Staff Report
City of Richmond, Virginia

Commission of Architectural Review

COA-103036-2021	Conceptual Review	Meeting Date: 12/21/2021
Applicant/Petitioner	Linnea Gerwig	
Project Description	Demolish a non-original addition and construct a new rear, two-story addition and shed.	
Project Location		
Address: 612 N. 27 th St.		
Historic District: Church Hill North		
High-Level Details: - The applicant proposes to alter the rear of an 1820s Federal Style, three-bay frame house. - The applicant proposes to demolish a non-original rear addition and construct a new two-story addition with a larger footprint in its place. - No changes to the front façade are proposed. - The applicant also proposes to construct a new storage building to the rear of the existing dwelling along the alley. - Minor, in-kind repairs to the front façade are also proposed.		
Staff Contact	Eva Campbell, eva.campbell@RVA.gov , 804-646-7550	
Previous Reviews	None	
Staff Recommendations	Staff recommends the following: - In order to more closely resemble the original fenestration pattern of the original second-story rear facade, the four windows comprising the proposed ribbon window feature on the second-story should

Figure 4. Footprint of original dwelling depicted on F.W. Beers Atlas (c.1877)

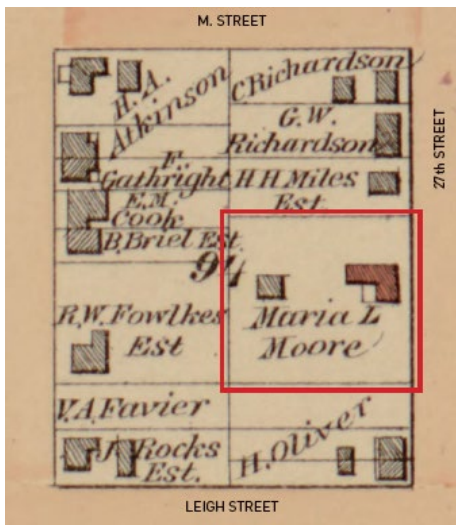
<i>building on the site, including roof slope and materials selection.</i> <i>2. Newly constructed outbuildings such as detached garages or tool sheds should respect the siting, massing, roof profiles, materials and colors of existing outbuildings in the neighborhood.</i> <i>3. New outbuildings should be smaller than the main residence and be located to the rear and/or side of the property to emphasize that they are secondary structures.</i>	design uses materials that will match the proposed rear façade addition. If the Commission determines that a contemporary design is appropriate for the proposed attached addition, staff recommends approval of the accessory structure, as proposed. Additionally, staff notes that historic maps indicate that accessory structures have been present on the property at various times (see Figures 4-6).
--	--	--
